City of Albuquerque

RE: DRAINAGE PLAN FOR B.H.I. PHASE II (L-21/D4)
ENGINEER'S STAMP DATED JUNE 22, 1991

DETAILS AND CALCULATIONS
B.H.I. - PHASE II

DRAINAGE PLAN

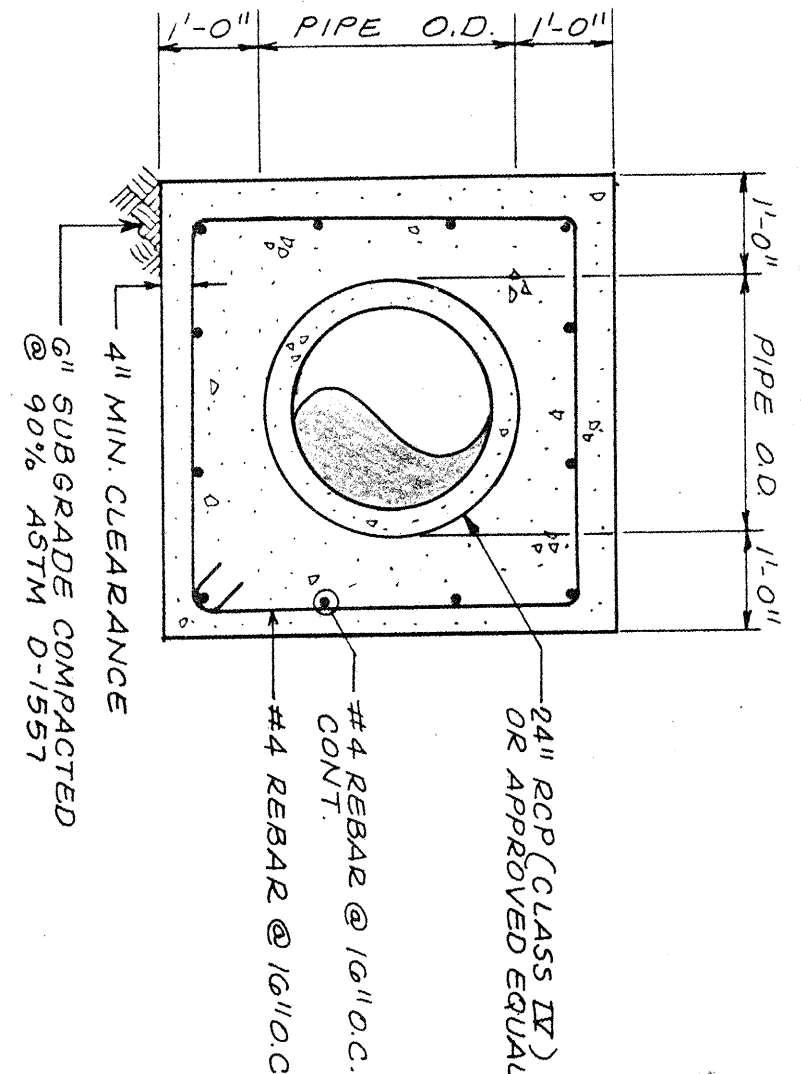
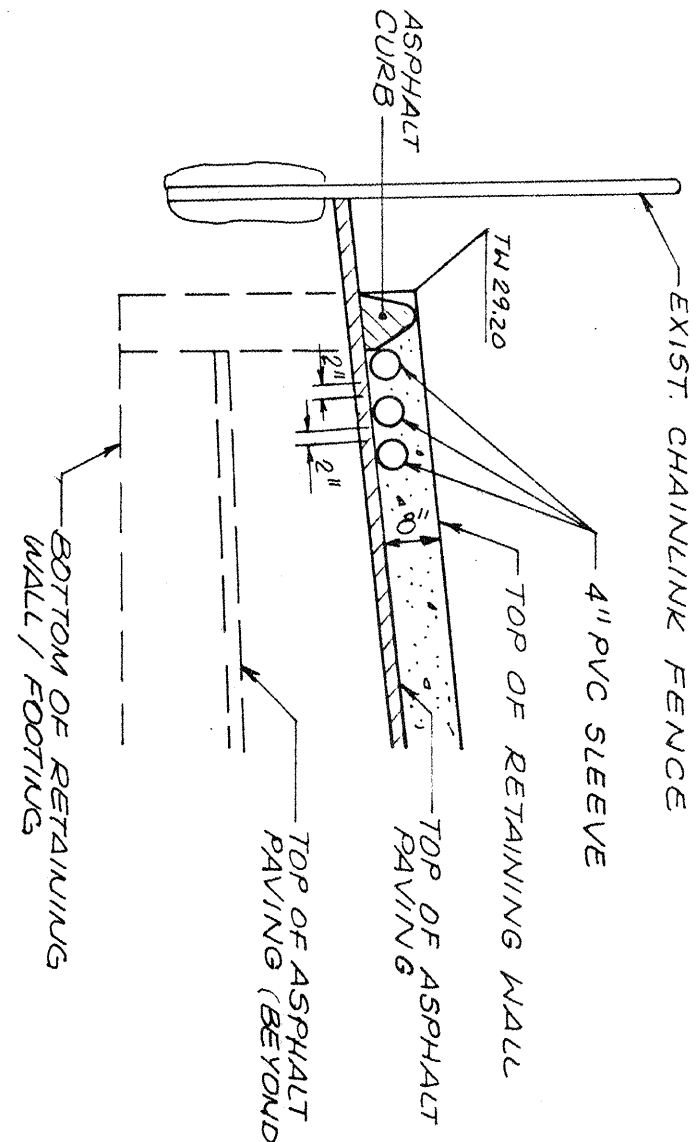
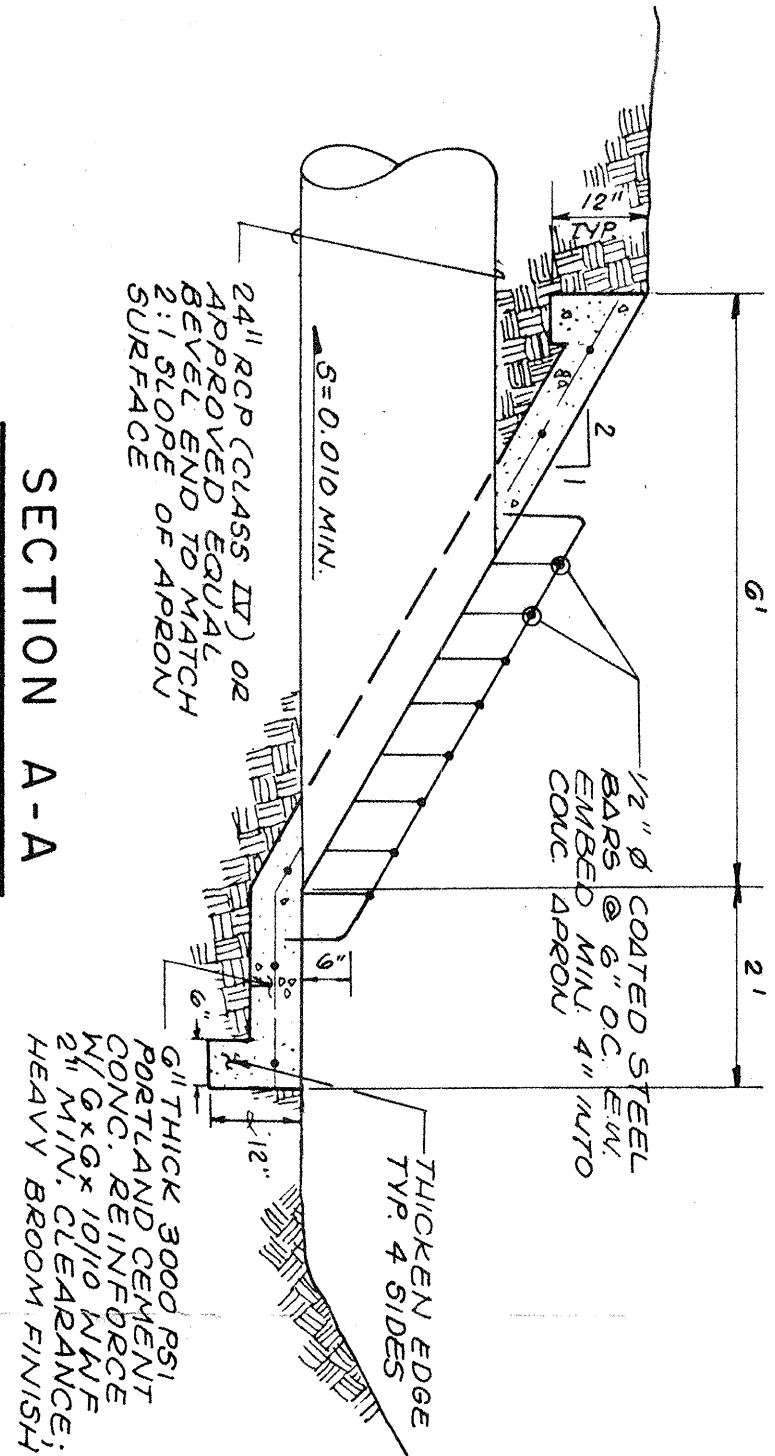
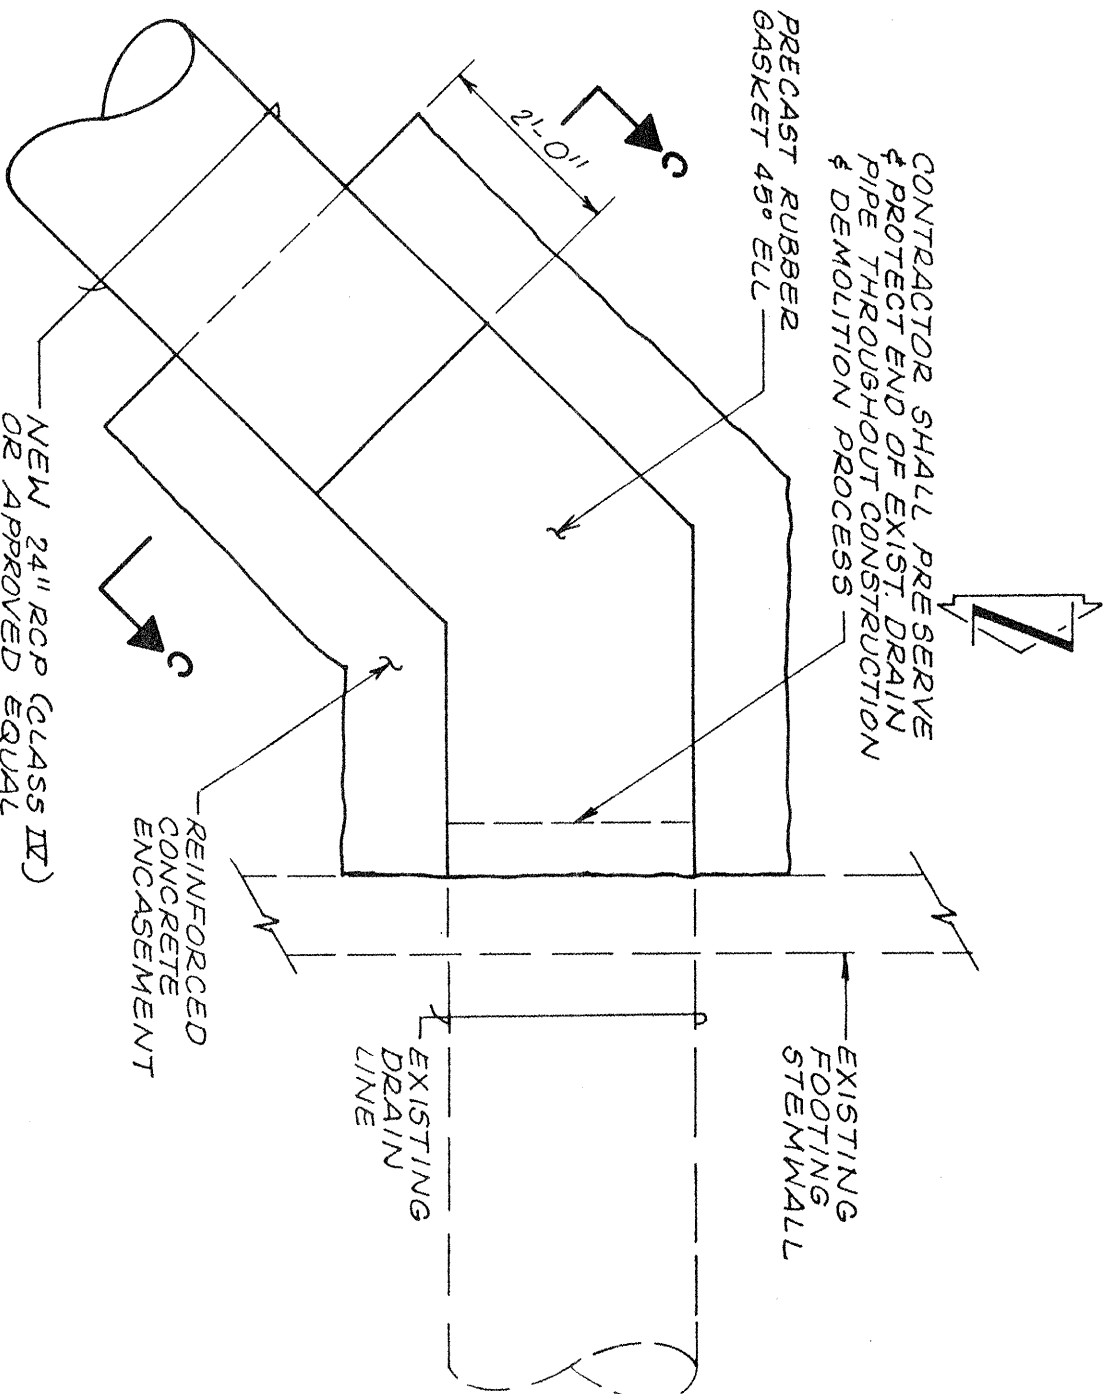
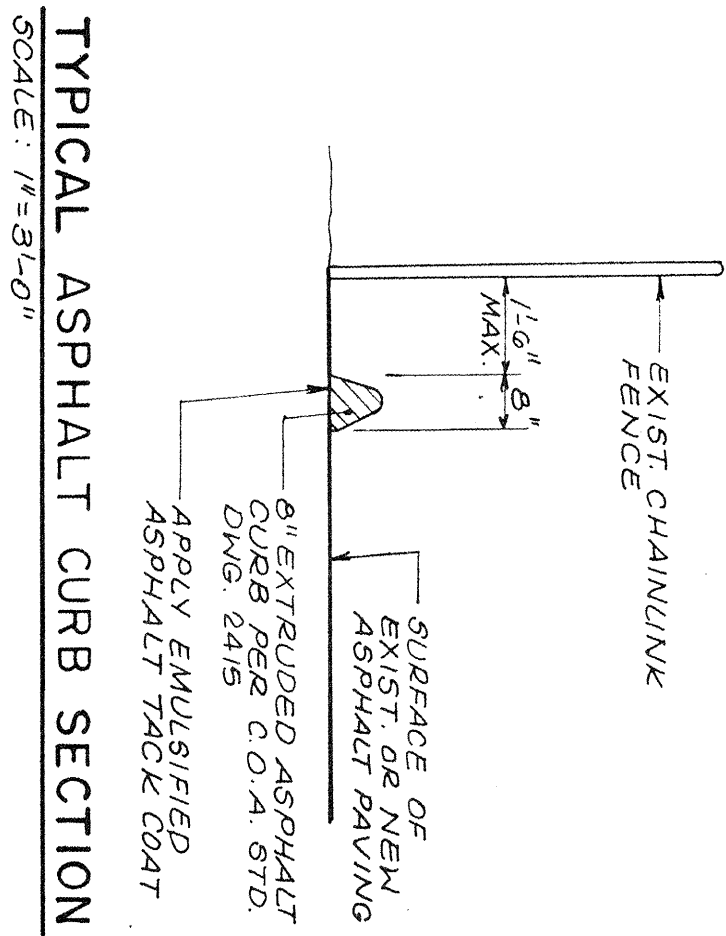
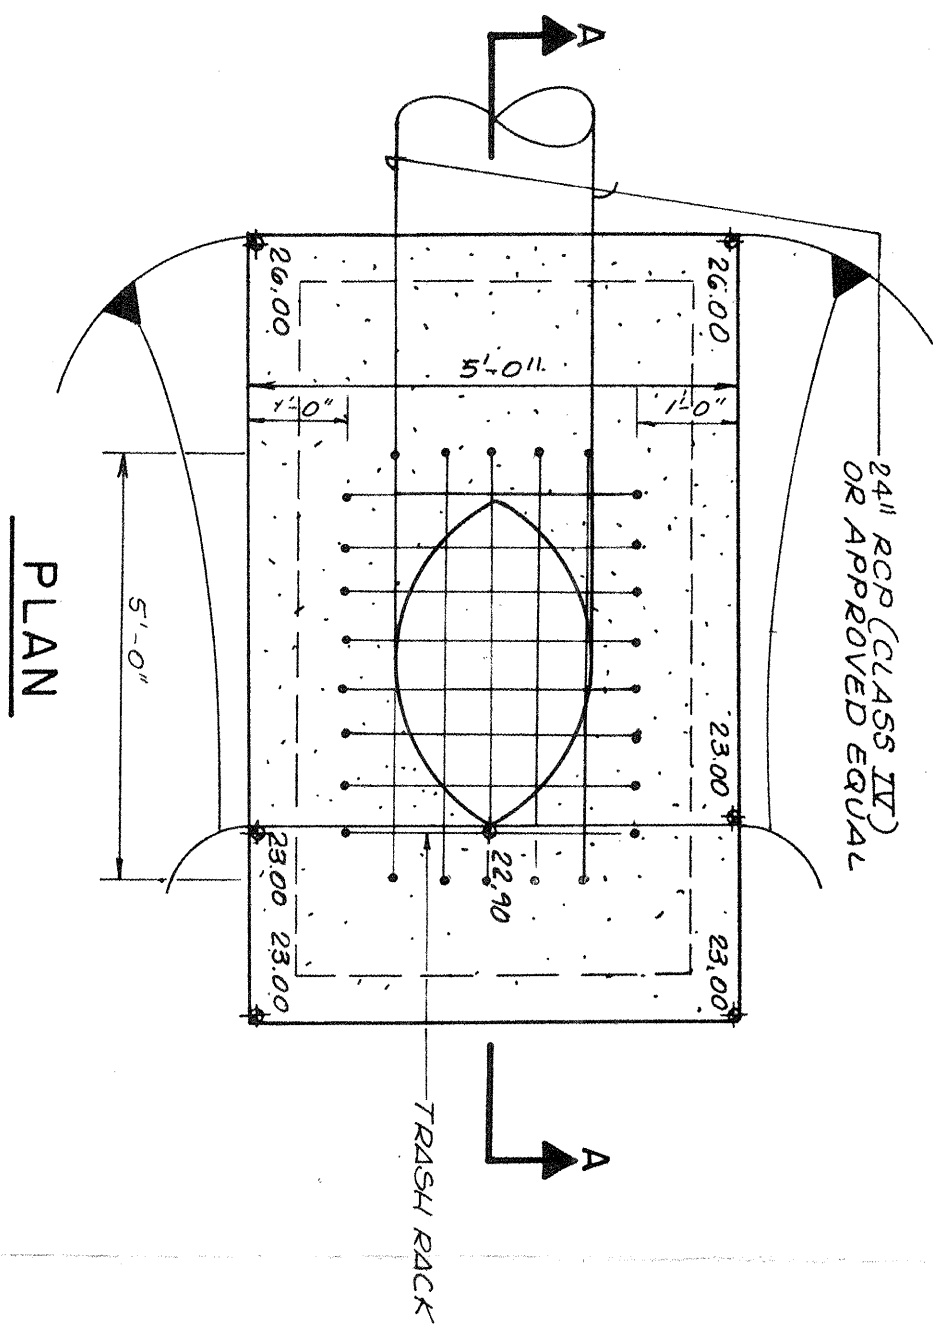
Based on the information provided on your submittal of June 26, 1991, the above referenced plan is approved for Building Permit.

Please attach a copy of this plan to the construction sets prior to sign-off by Hydrology.

All underground systems must be certified prior to Certificate of Occupancy release.
